RE: Drainage Plan for Zamora Well No. 2 (E10-D2H) Received June 2, 1997

**RE: ZAMORA WELL NO. 2 (E10-D2H). GRADING AND DRAINAGE PLAN FOR SITE
DEVELOPMENT PLAN FOR BUILDING PERMIT AND BUILDING PERMIT APPROVAL.
ENGINEER'S STAMP DATED MAY 30, 1997.**

TITLE: ZAMORA WELL NO. 2
SITE GRADING AND DRAINAGE PLAN

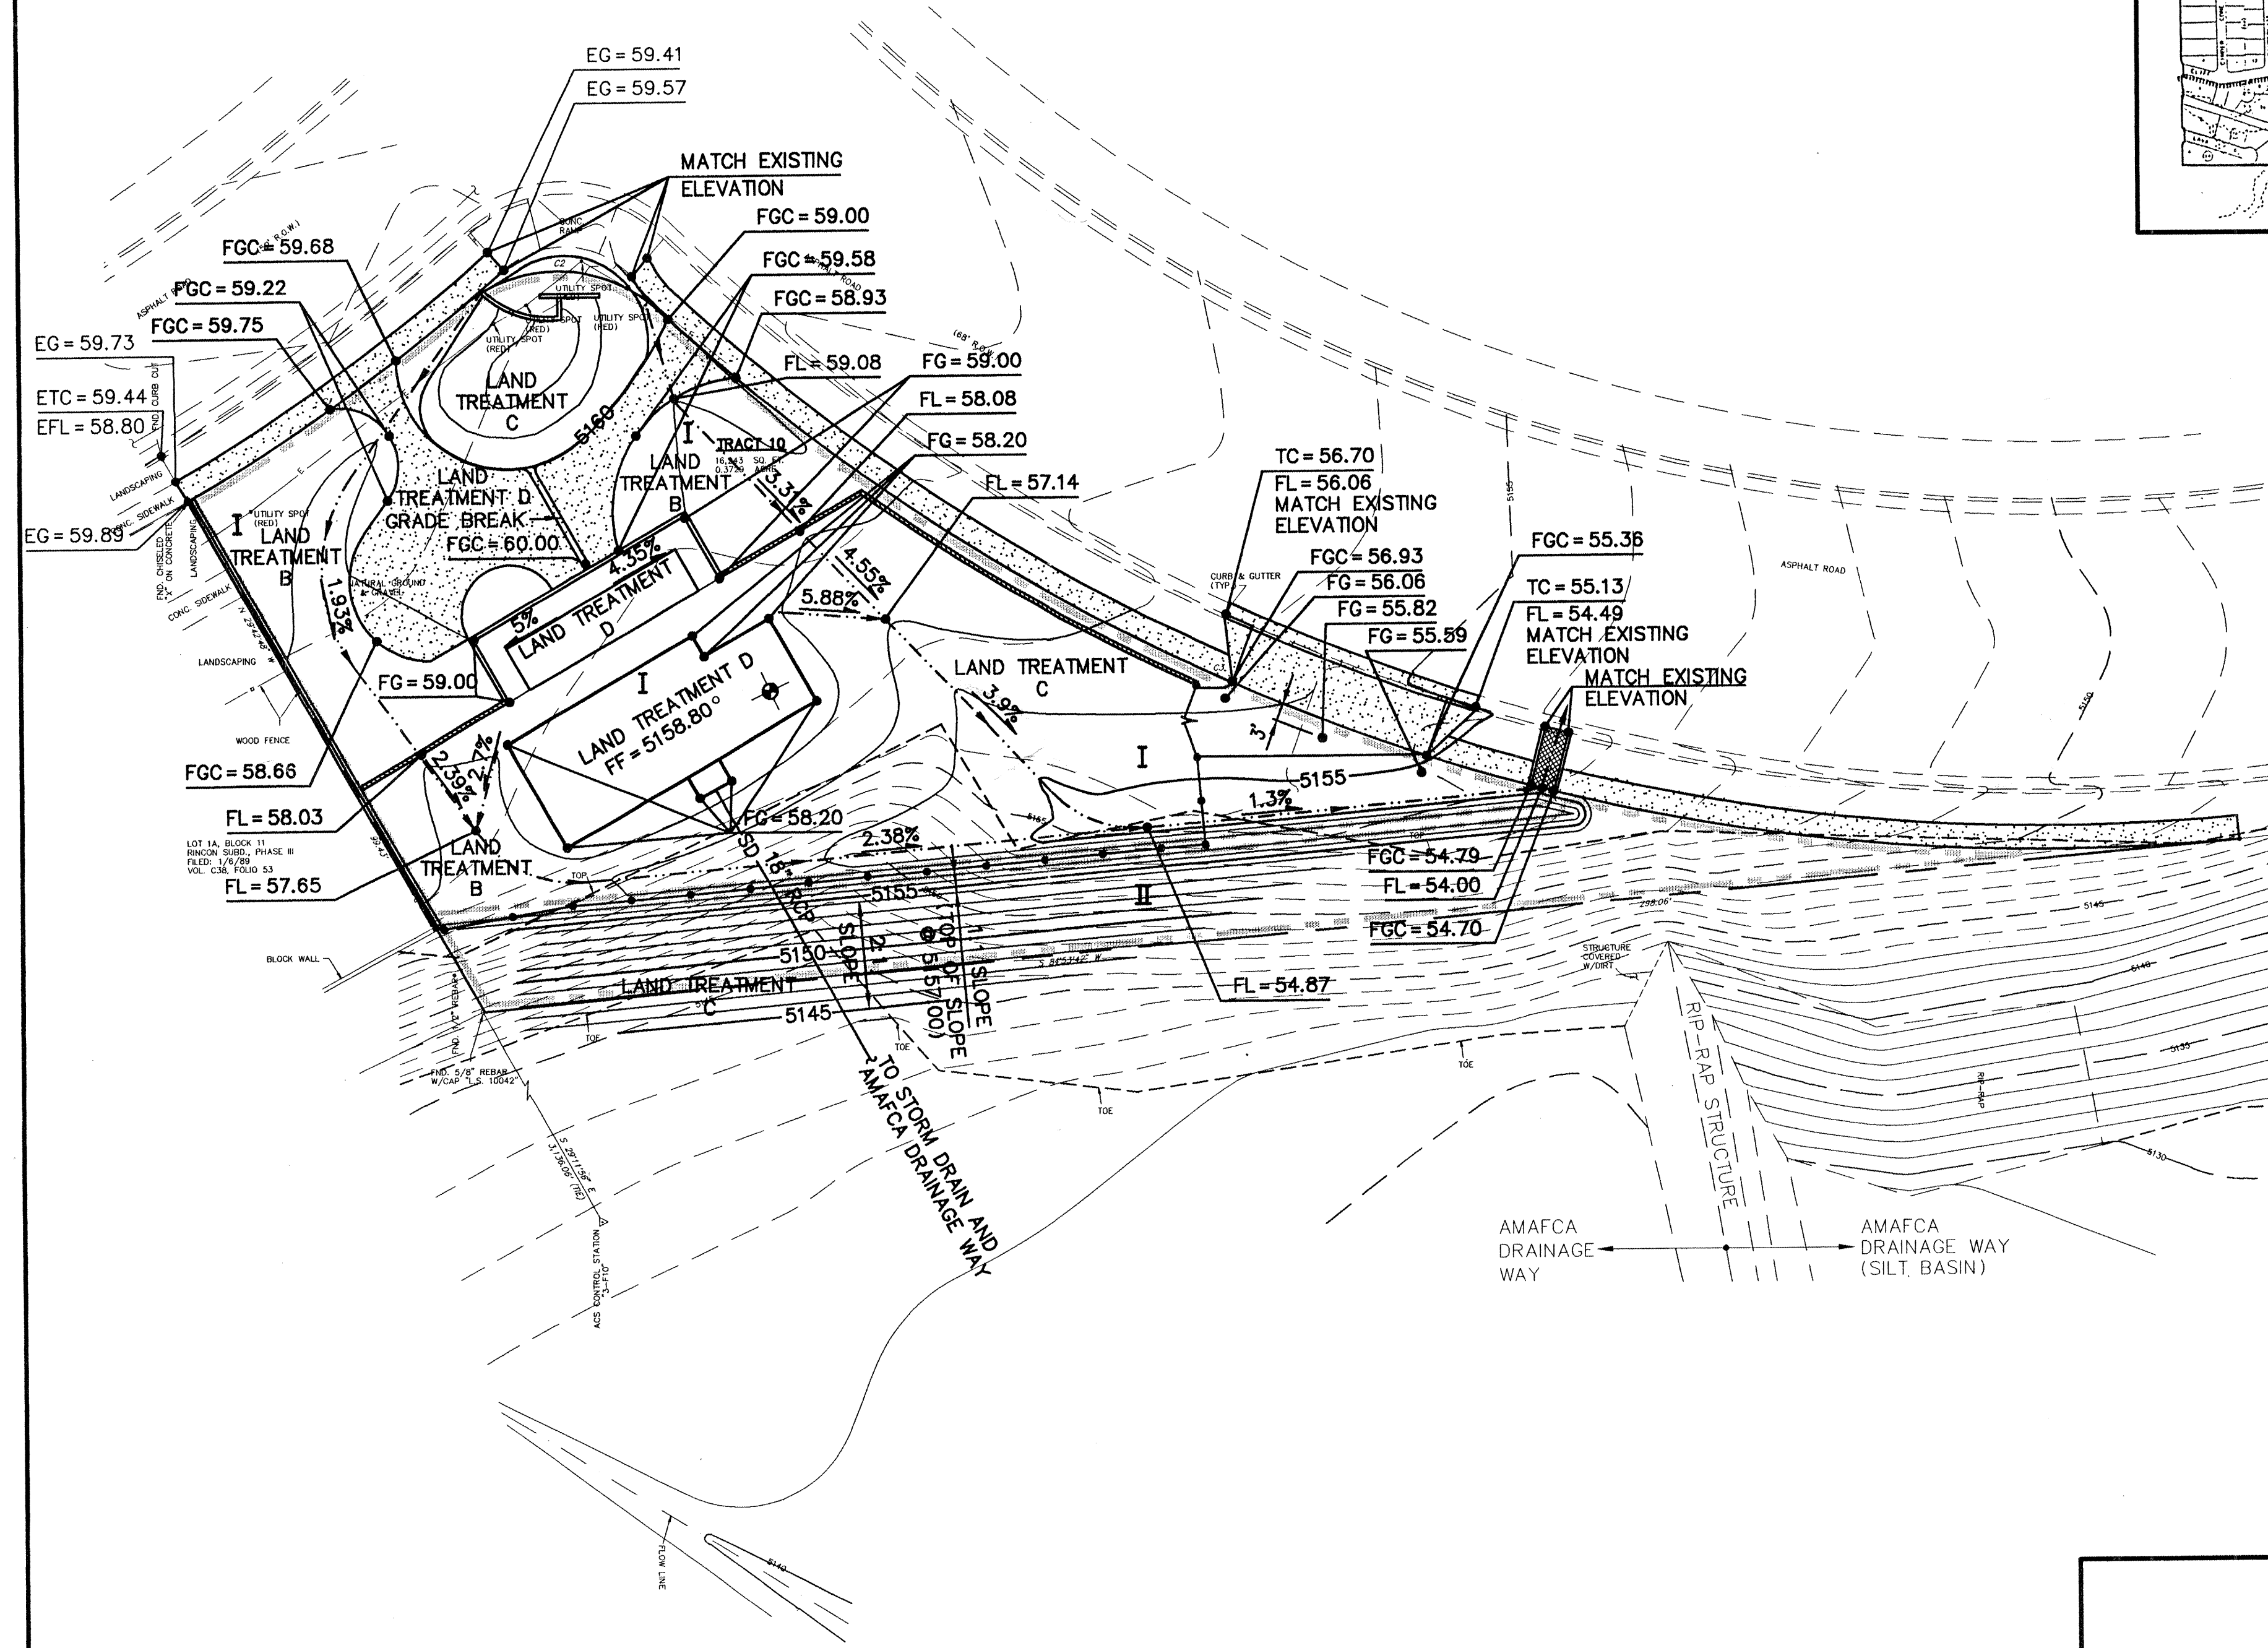
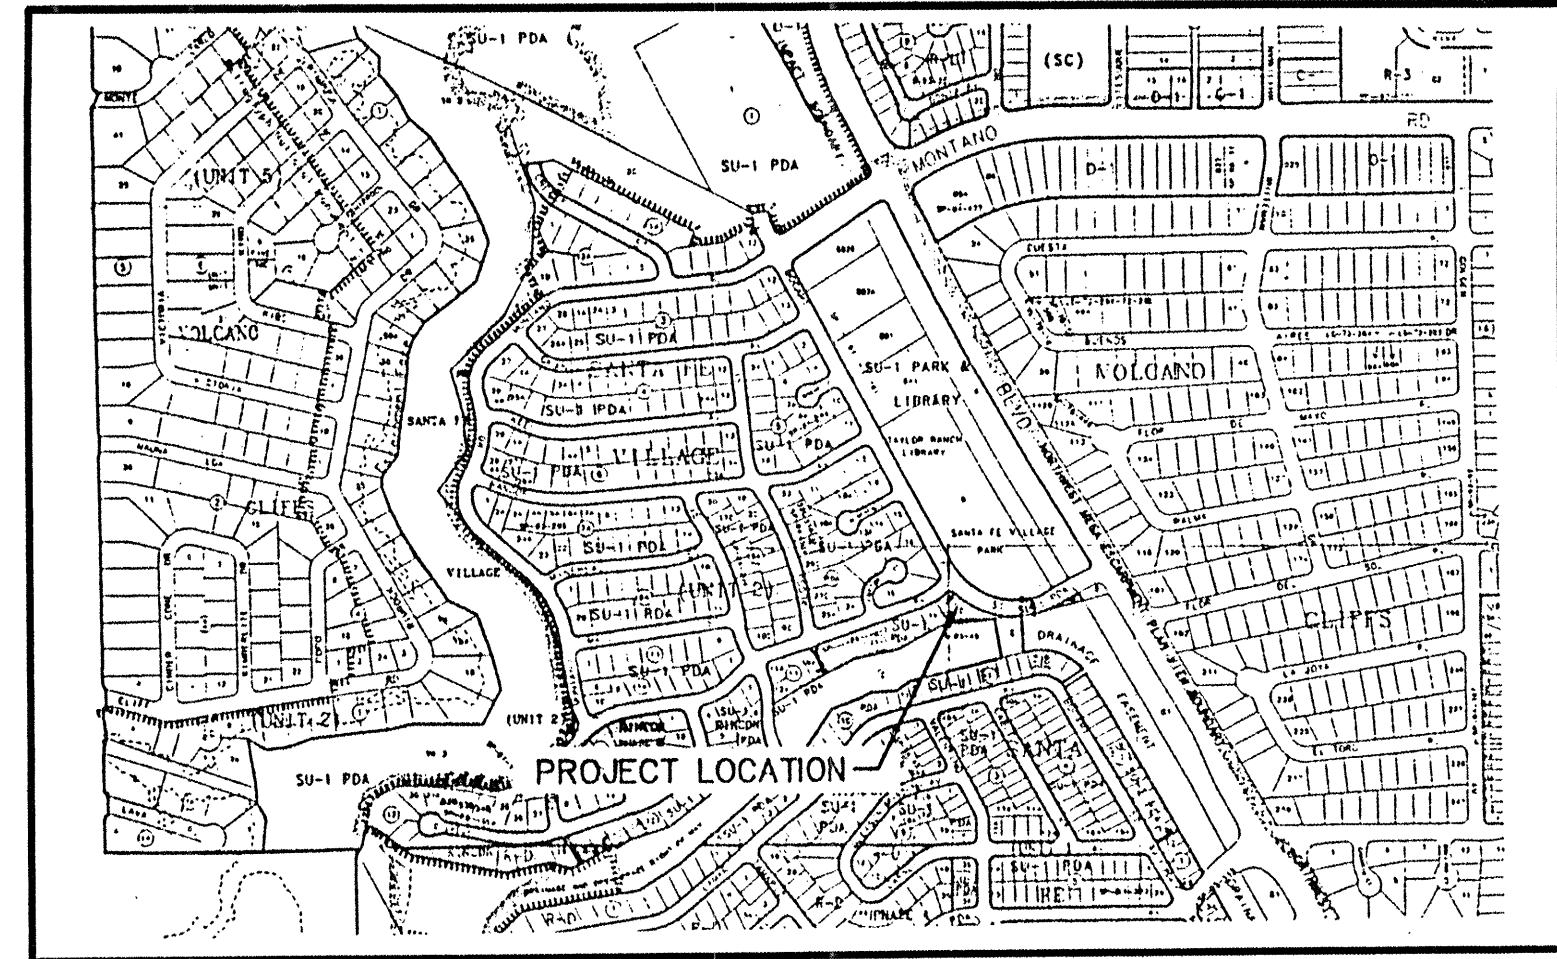
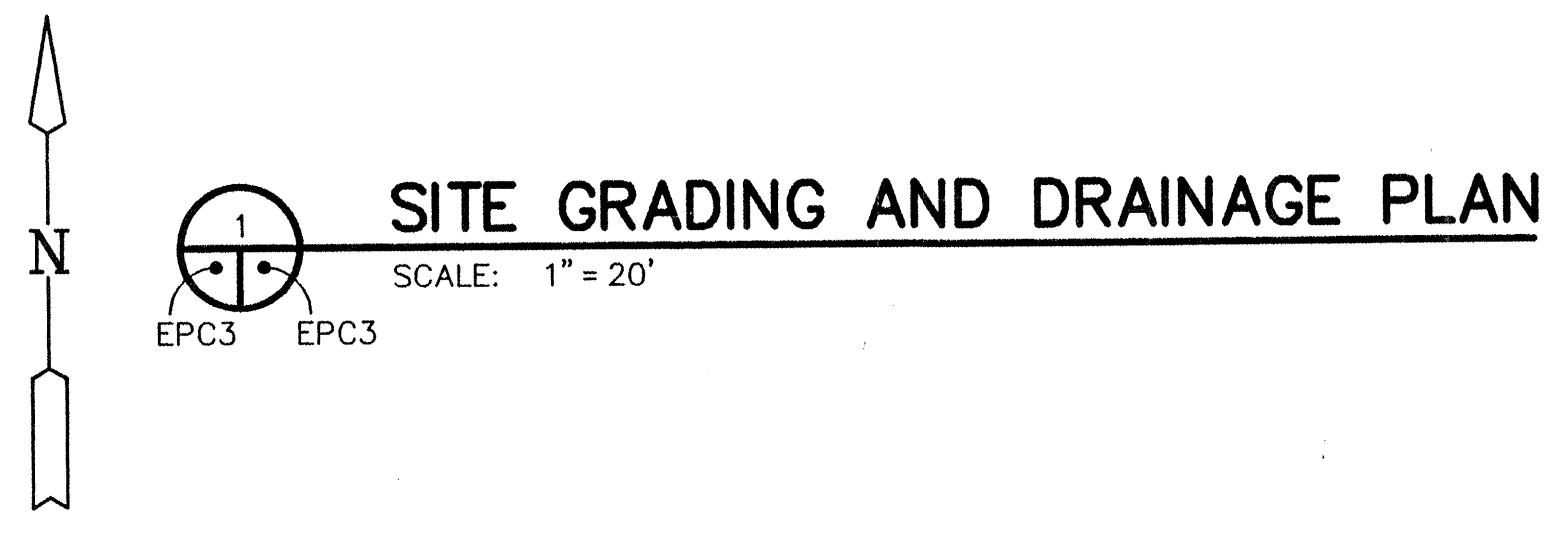
AMAFCA has reviewed the grading and drainage plan for the subject wellsite. I am pleased that the existing 18" RCP is still in usable condition for the site drainage. Four comments need to be addressed prior to AMAFCA approval:

- The fill slope along the north bank of the arroyo shall be installed at 95% compaction (ASTM 1557).
- The slope and all disturbed areas shall be reseeded per the City's westside seed mix. The slope shall then be plated with 2" of 3/4 to 1-1/2" "Santa Ana Tan" gravel as a mulch.
- The toe of the fill slope on the arroyo will be protected with 60' of 3-4' basalt boulders installed at the toe of the slope along elevation 5145. These boulders are available from AMAFCA free of charge.
- The specifications need to include AMAFCA as an additional insured.
